## **MONITORING YEAR 3 ANNUAL REPORT**

### **OWL'S DEN MITIGATION SITE**

Lincoln County, NC  
DEQ Contract 005150  
DMS Project Number 95808

RE: Owl's Den Mitigation Site-Year 3 Monitoring Report  
Final Submittal for DMS  
Contract Number 004673, RFP Number 16-004110, DMS# 95360  
Yadkin River Basin – CU# 03040105; Union County, NC

**Table 5a. Visual Stream Morphology Stability Assessment Table**

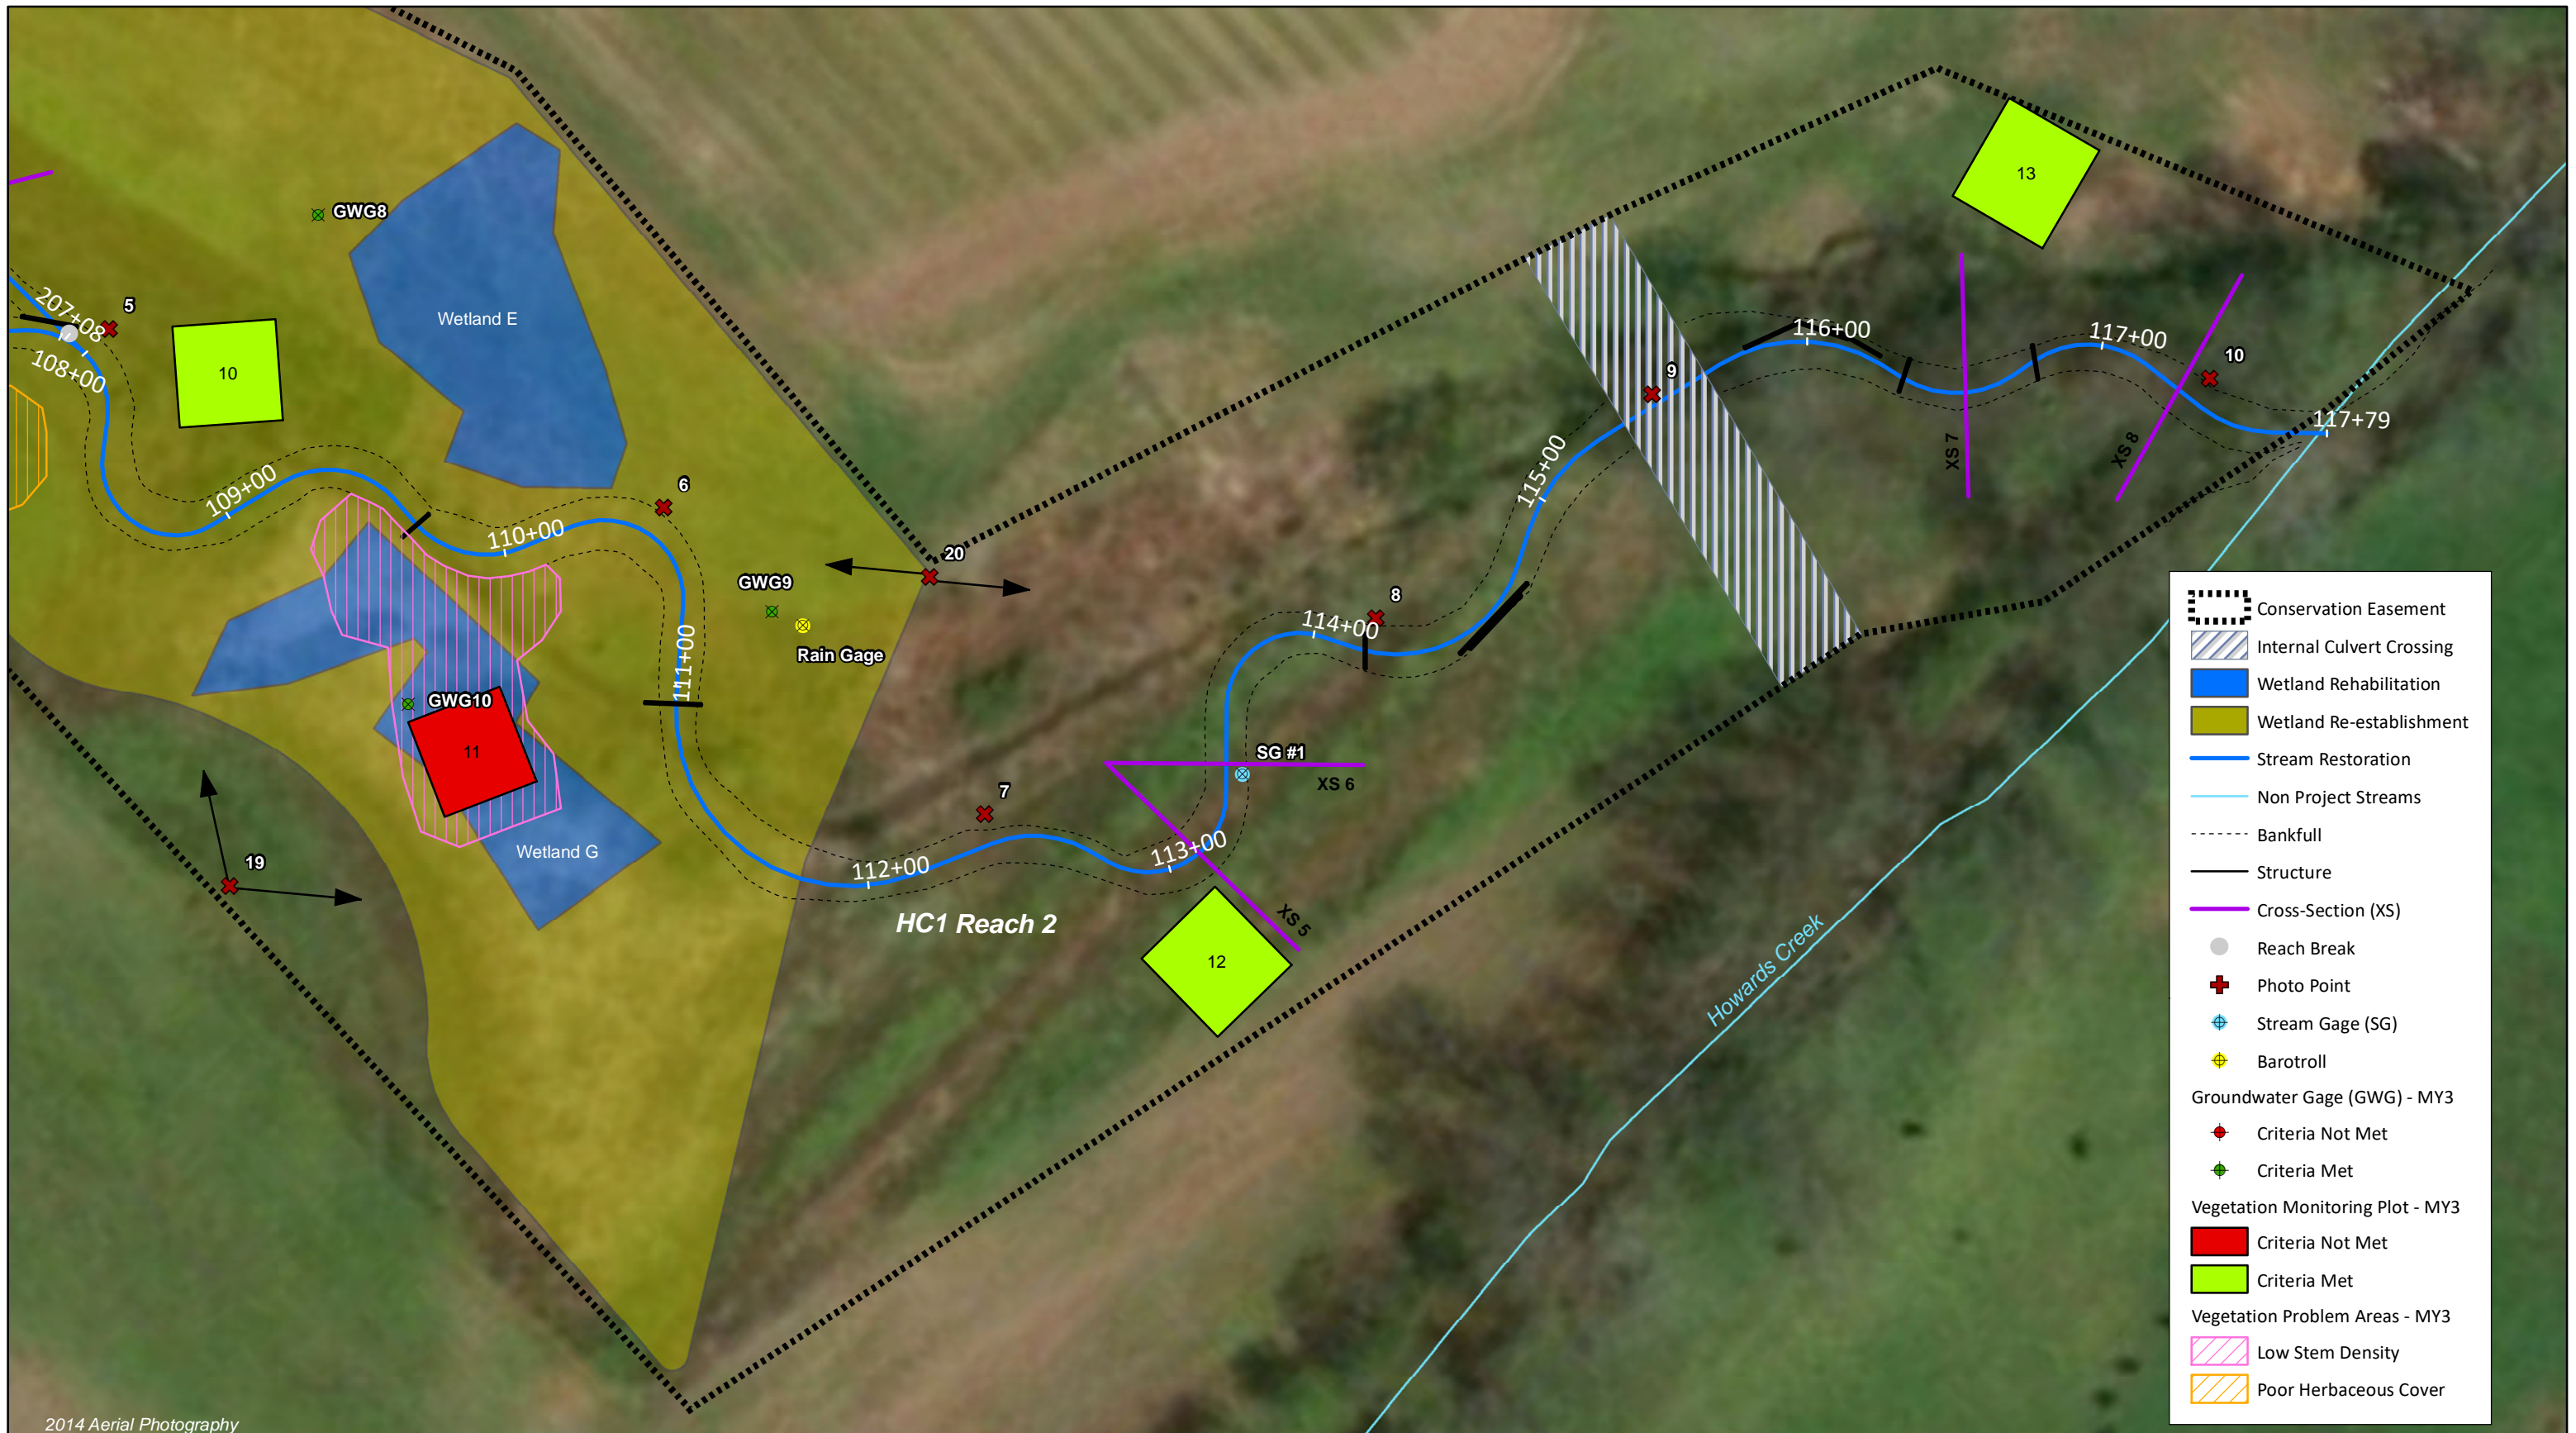
**DMS Comment; General: The report text indicates that an additional groundwater gage and a soil temperature probe will be installed and monitored in MY4. Please show the proposed locations of the additional MY4-MY7 monitoring equipment on the CCPV sheets.**

*Wildlands Response; The CCPV sheets have been updated to reflect the additional groundwater and soil temperature probe proposed locations.*
